COMMENTS ON APPLICATION FOR 26 NETHERHALL GARDENS 2015/3314/P

THIS REPORT IS PREPARED ON BEHALF OF THE OWNERS OF 24A NETHERHALL GARDENS WHICH ADJOINS THE APPLICATION SITE

TREES VIEWED FROM THE FIRST FLOOR REAR / SIDE WINDOW TO 24A NETHEHALL GARDENS

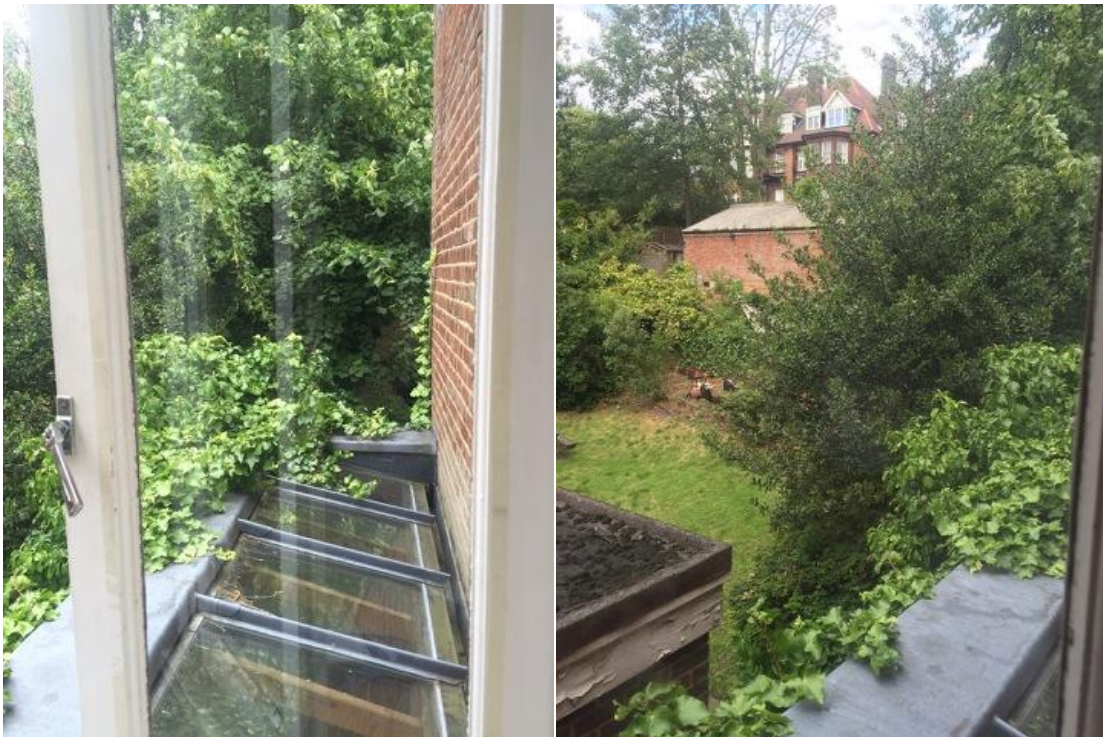
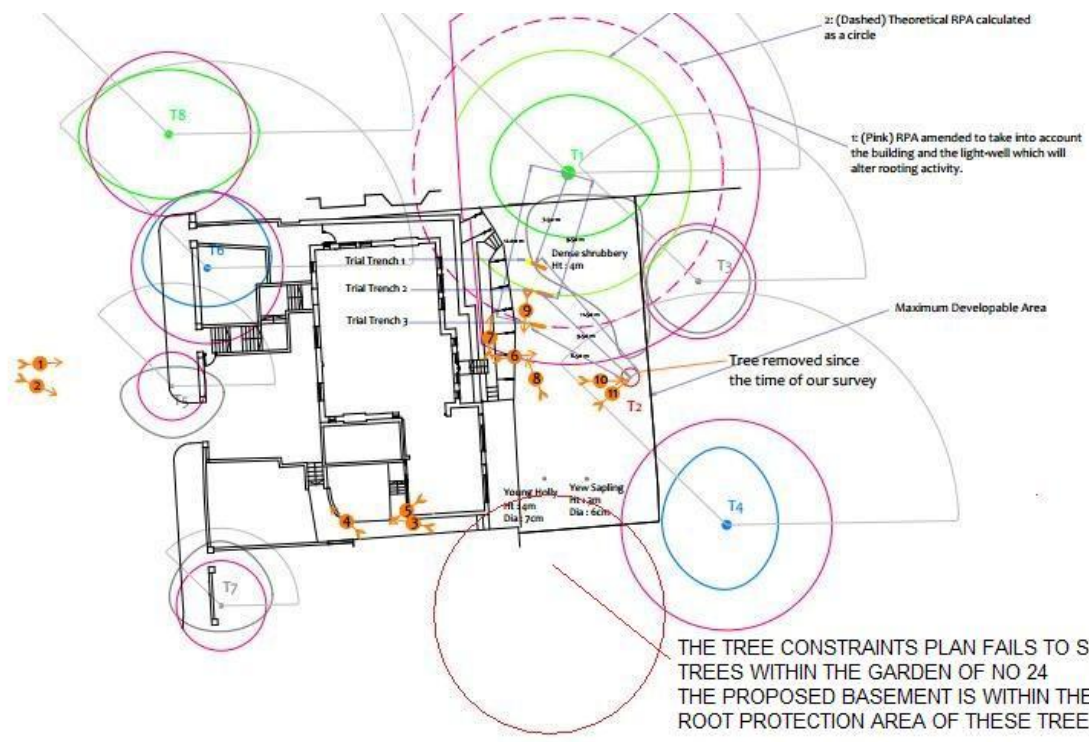
This reason for refusal is still valid as the proposed application fails to take account of trees which are in the garden of No 24A on the boundary

THE TREE CONSTRAINTS PLAN FAILS TO SHOW TREES WITHIN THE GARDEN OF NO 24 THE PROPOSED BASEMENT IS WITHIN THE ROOT PROTECTION AREA OF THESE TREES

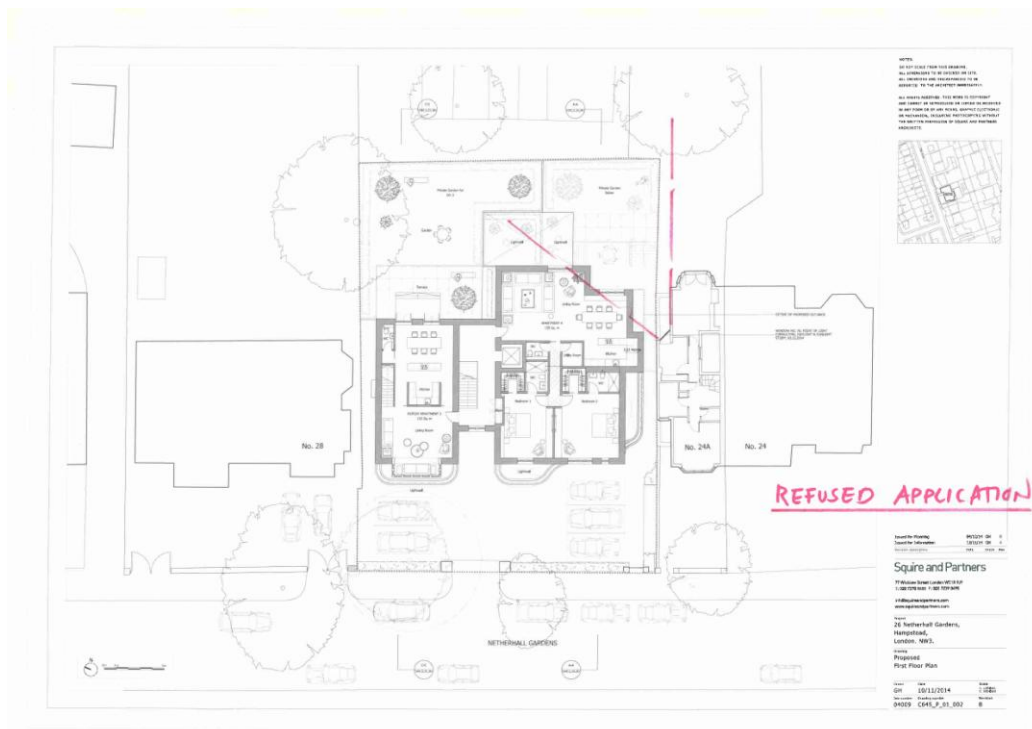
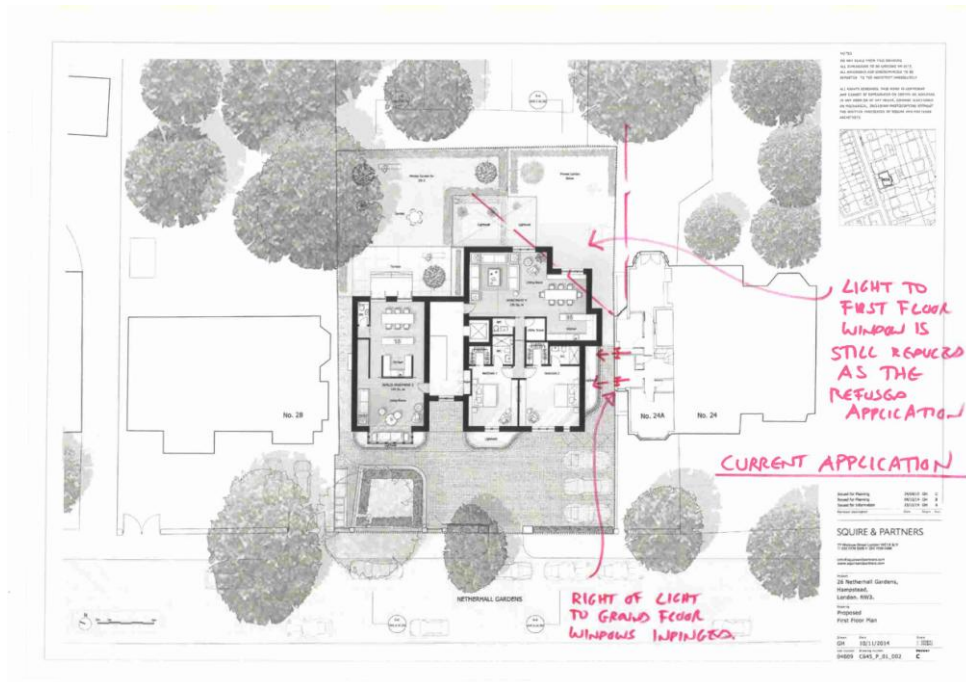
The existing first floor window to the bedroom at No 24A has a window which is at 45deg to the boundary, and currently enjoys light and views as illustrated below.

The relationship between the first floor windows, and the ground floor windows on the boundary has not altered since the previously refused application.
